SEWAGE DISPOSAL SYSTEM

HOWARD COUNTY HEALTH DEPARTMENT

A REPAIR

SUBDIVISION Gwyndyl Oak Estates LOT 33 ROAD 2840 Rolling Fork Way

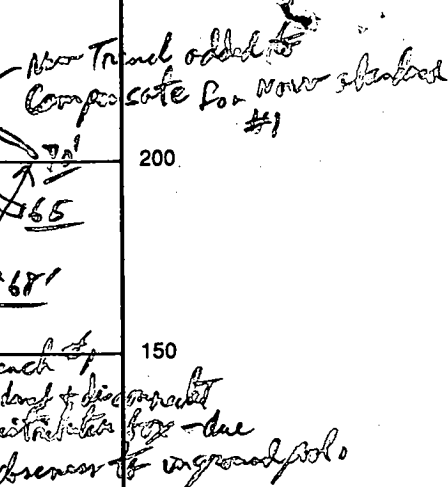
Plan change - change by eliminating Septic Trench #1 and add a replacement trench (65 ft) parallel to + down slope (on right hand side) of old Trench #2 (65 ft long). Change approved conversation Jack Fyock (Ch/Padg) 8/17/97

REMARKS: Old section of ditch, collapsed & gravel filled in place. New S.T. New Trench connects to old. Last box was ok to cover - old #1 trench is connected just at last box. JEP 8/25/87

LOT 33

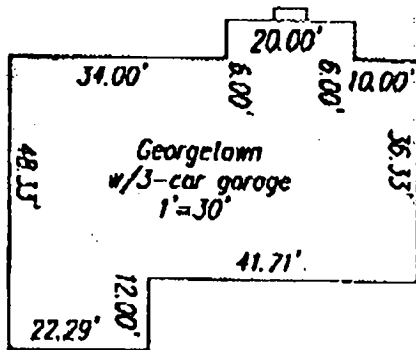
11/14/96
 prepare final
 location OK
 as shown (DK)

AREA 3

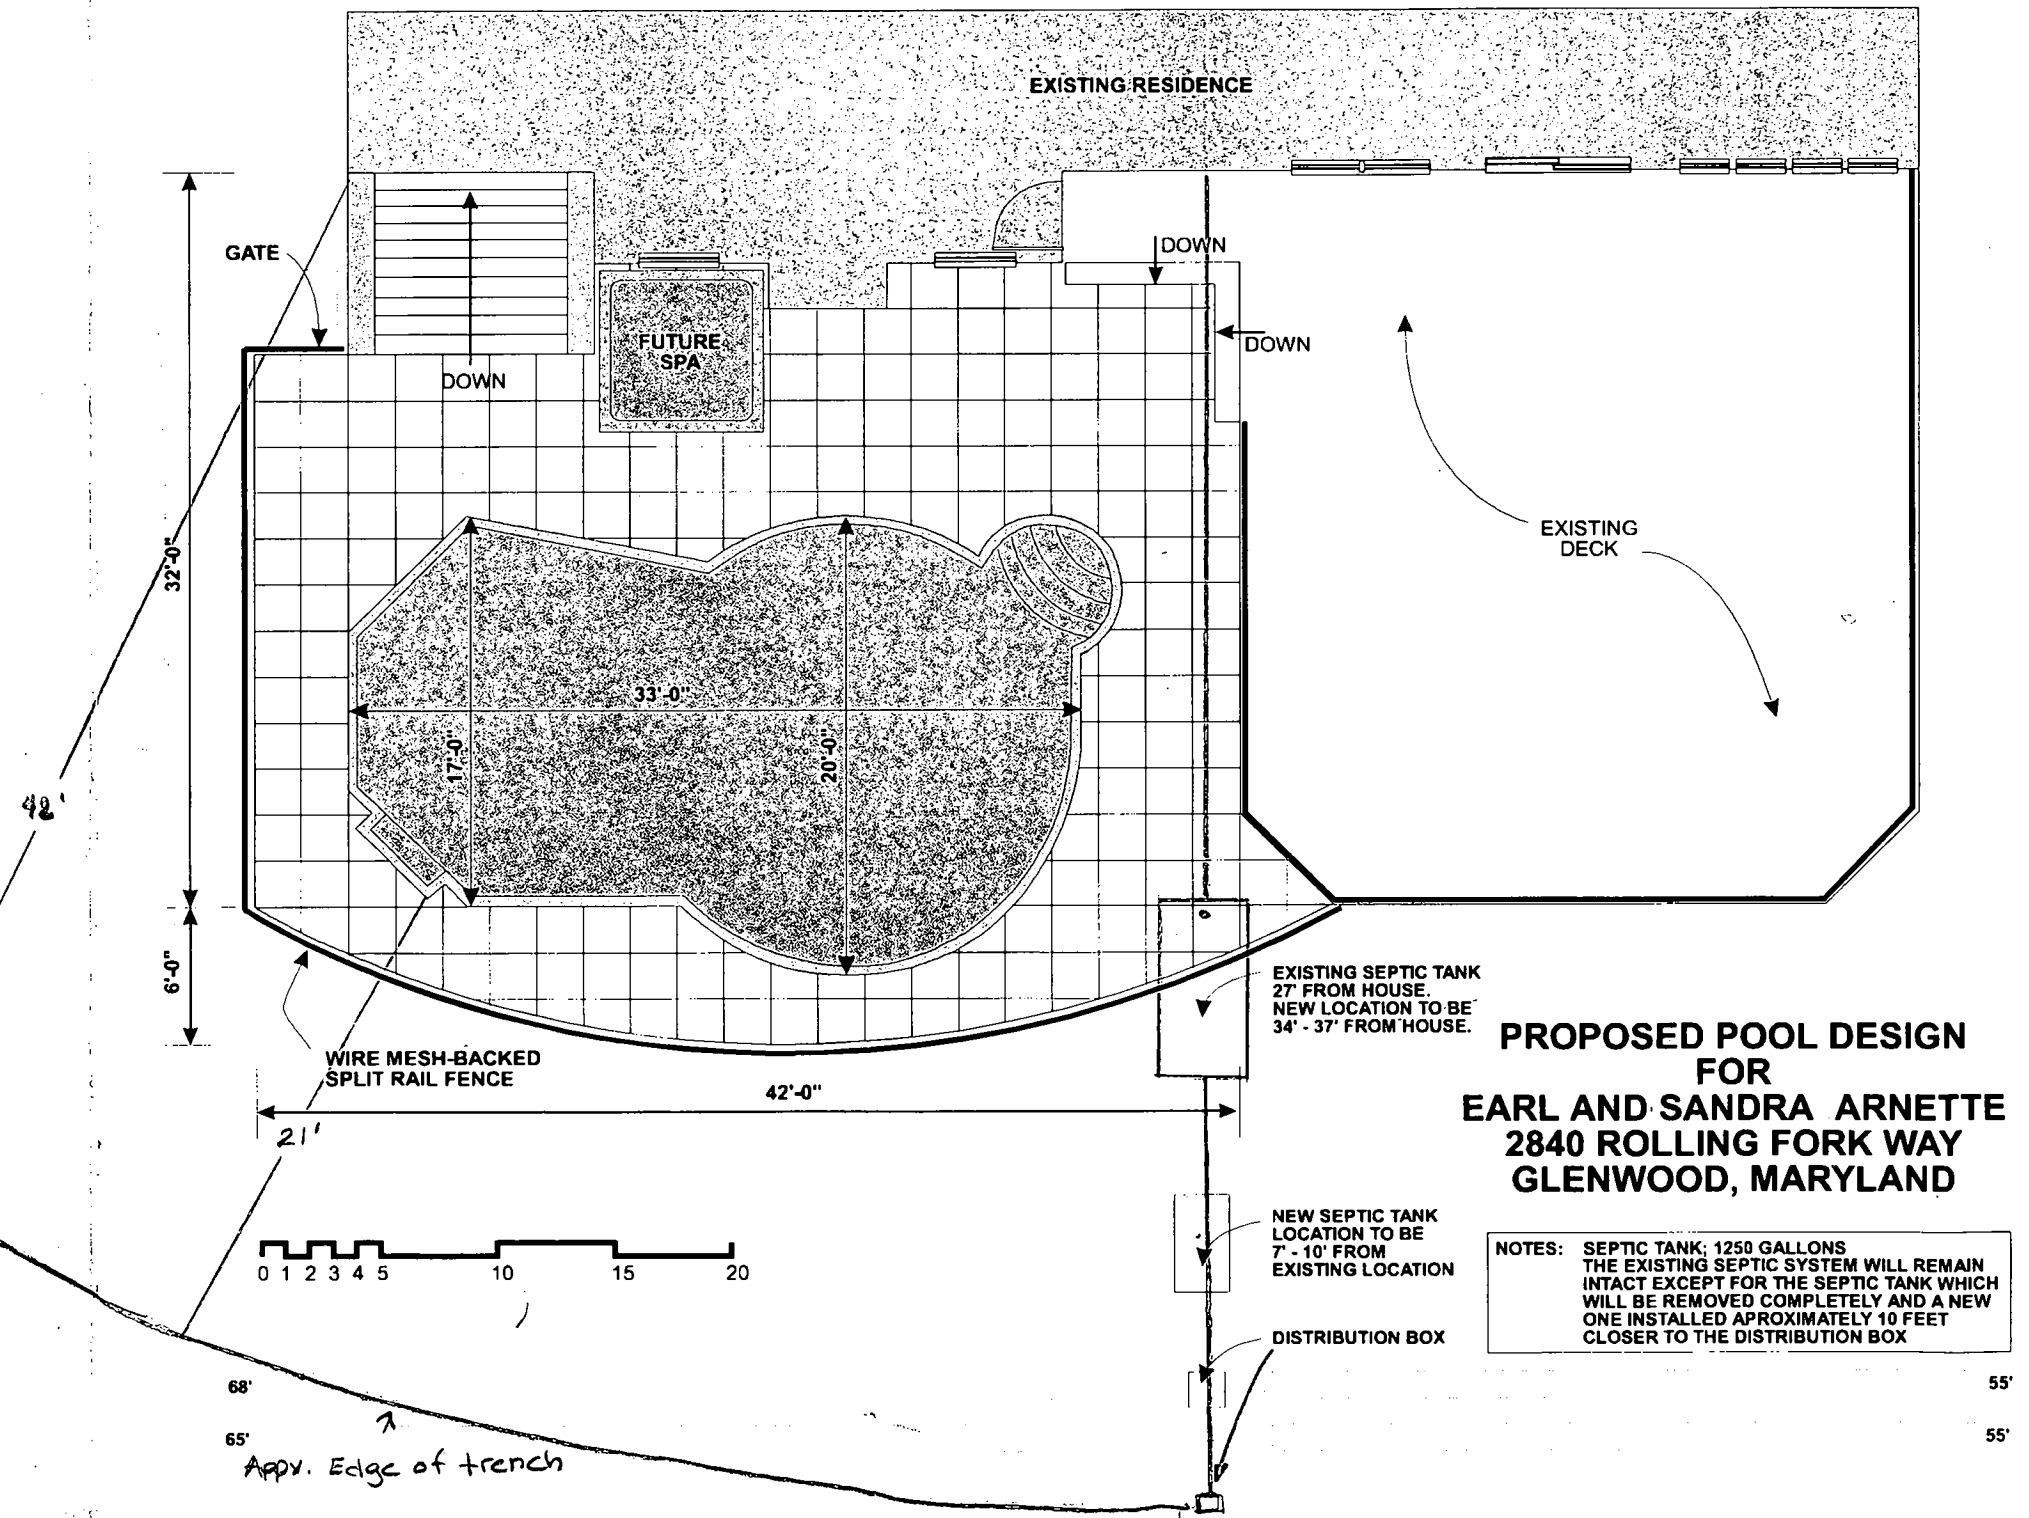
7-29-97
BP preview for
a pool

Location of pool
OK provided the
septic tank is
moved 17-10' away
from the deck.
Well is in the front.
Owner was informed
on this date about
obtaining a repair
permit prior to
BP approval
ALM

8-13-97
B00107405
Approved
ALM
